Taycha Wolfries
Covenants Advisor
Reston Association
12001 Sunrise Valley Dr.
Reston, VA 20191

RE: St Johns Wood Community Redevelopment Plan Approved by the RA DRB on July 19, 2016 – Request to Speak at Design Review Board (DRB) as Affected Party.

Suggested alternative exit from St Johns Wood Cluster across from the Great Owl Drive on Reston Parkway.

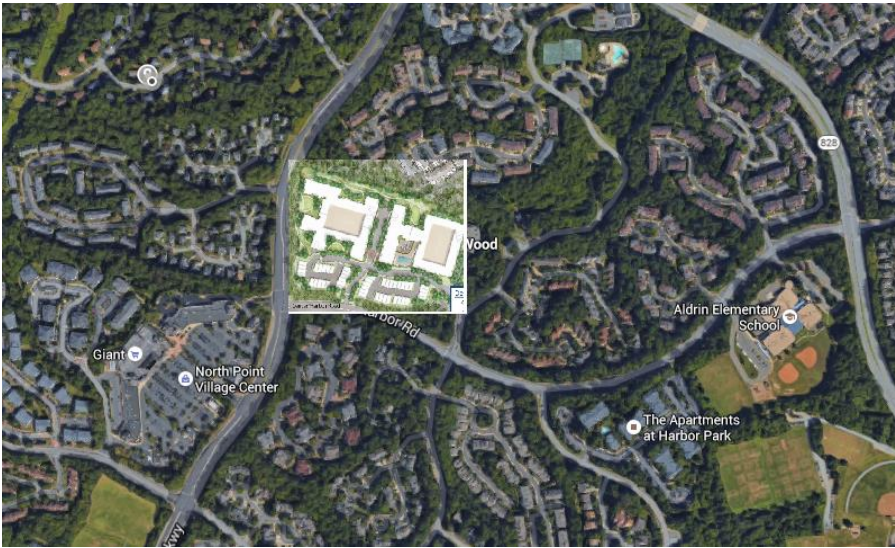
1.1 Traffic exit design needs to be revisited/changed. A new exit onto the Center Harbor Road across from Church Hill Place will create traffic increases in both directions on Center Harbor Road. In addition, the current exit on North Point Village Road will not be able to absorb more traffic without disruptions to the surrounding walk path ways in the neighborhood. Our recommendation is that the exit of this new cluster drop out onto Reston Parkway across from Great Owl Drive. (See picture below for recommended changes to cluster exit).

1.2 The new exit needs to be ready in advance of all deconstruction and construction traffic activities so as to limit construction traffic on all minor roads (Center Harbor, North Village etc.)
